South Texas Project  
Units 3 and 4  
Docket Nos. 52-012 and 52-013  
Response to Request for Additional Information

Attached are responses to NRC staff questions included in Request for Additional Information (RAI) letter number 242 related to Combined License Application (COLA) Part 2, Tier 2 Section 6.2.

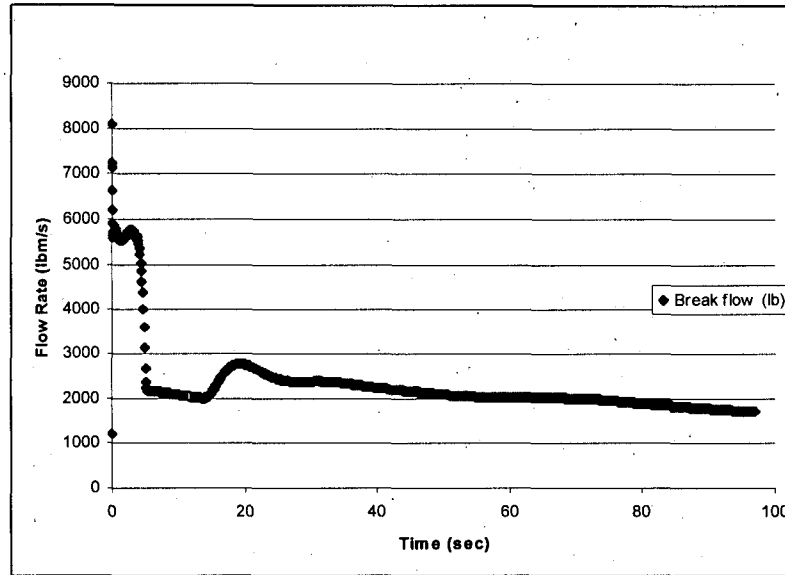
- a) Explain why the GOBLIN calculated total break flow rate is lower than the ABWR DCD break flow rate during the initial time interval of 0 to 3 seconds following the accident (see Figure 6-11 of WCAP-17058-P Rev 0 (June 2009) ).
- b) Provide the diameter, length, and pressure loss coefficients for each pipe segment in the main steam line. This should include the Main Steam Isolation Valve (loss coefficient and the fully open flow area) and the main steam line nozzles as used in the GOBLIN input deck. In addition, provide any additional pressure losses considered for the main steam line system in the GOBLIN model.

- a) An enhanced plot of Figure 6-11 of WCAP-17059-P Rev 0 is included below. The initial surge in flow reaches a peak value around 8000 lbm/s, which is comparable to the initial flow from the DCD. This could not be seen in the original figure because it drops off so quickly. Flow values for GOBLIN and the DCD match initially and at 5 seconds, when the Main Steam Isolation Valves (MSIVs) are closed. The latter point shows that the flow coming from the containment side of the break is consistent between the two models.
- b) Differences are likely due to the additional Main Steam Line (MSL) piping detail present in the GOBLIN model; the DCD appears to be a simpler calculation. GOBLIN models the piping present in the steam lines so it better shows the initial blow down of steam (the first second); it also shows the subsequent drop-off in flow associated with the closure of the MSIVs.
